TROPICAL TIMBER PLANTATIONS BEAGLE BAY PROJECT

PUBLIC ENVIRONMENTAL REVIEW SUBMISSIONS RESPONSES

MAY 2005

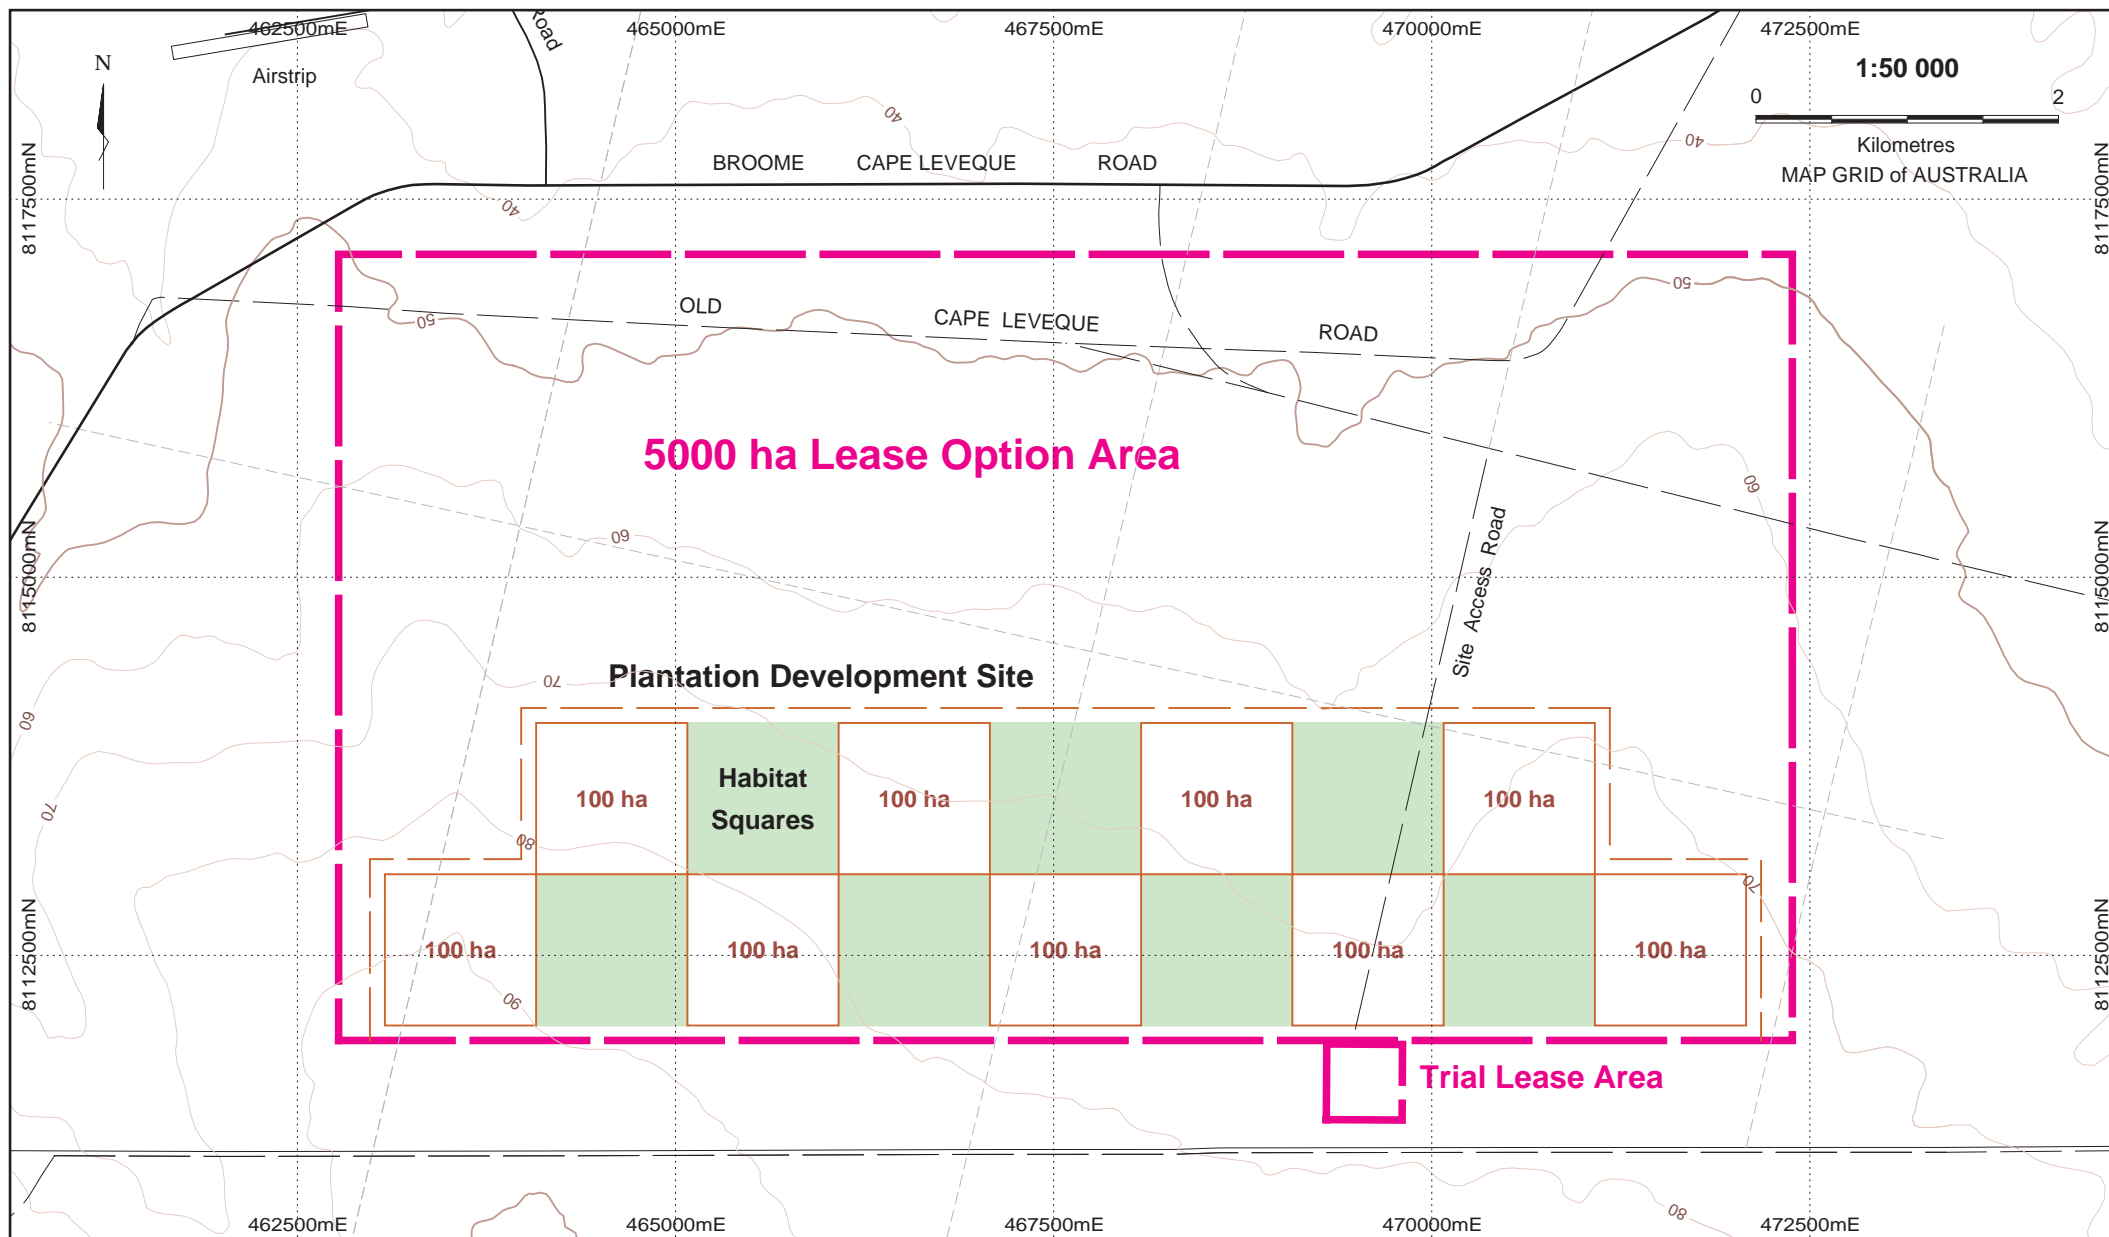
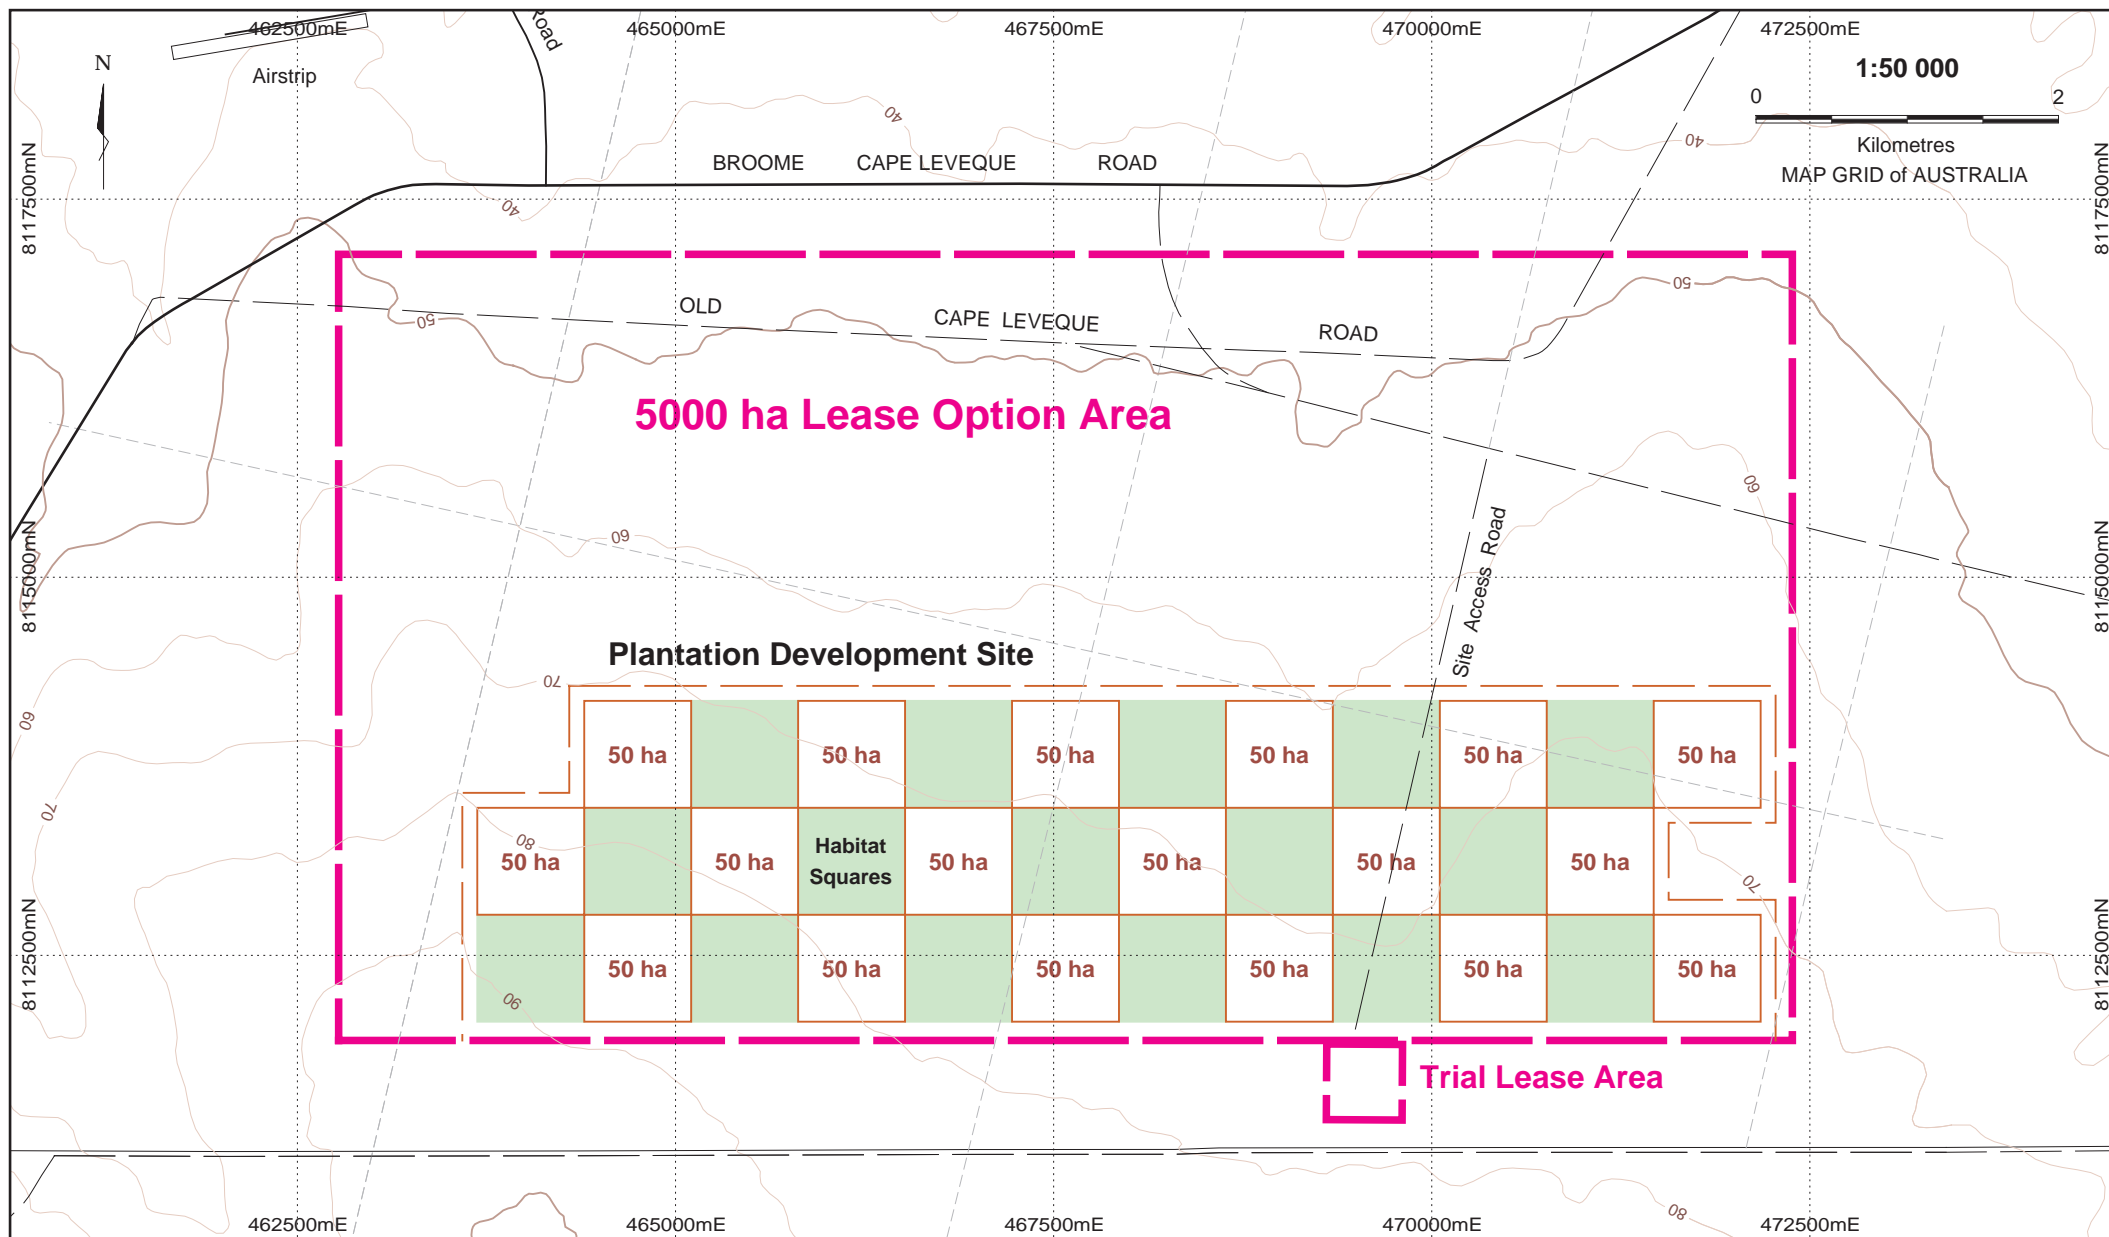
Figures 3.4 and 3.5 are also incorrectly titled ‘Stage 2’ – they show only stage 1 plots. We need to be able to see the proposed Stage 1 clearly delineated.

Response: *The Proponent acknowledges that many of the figures were confusing and has corrected the figures to relate to Stage 1 of the project only. These revised figures are provided in Appendix A.*
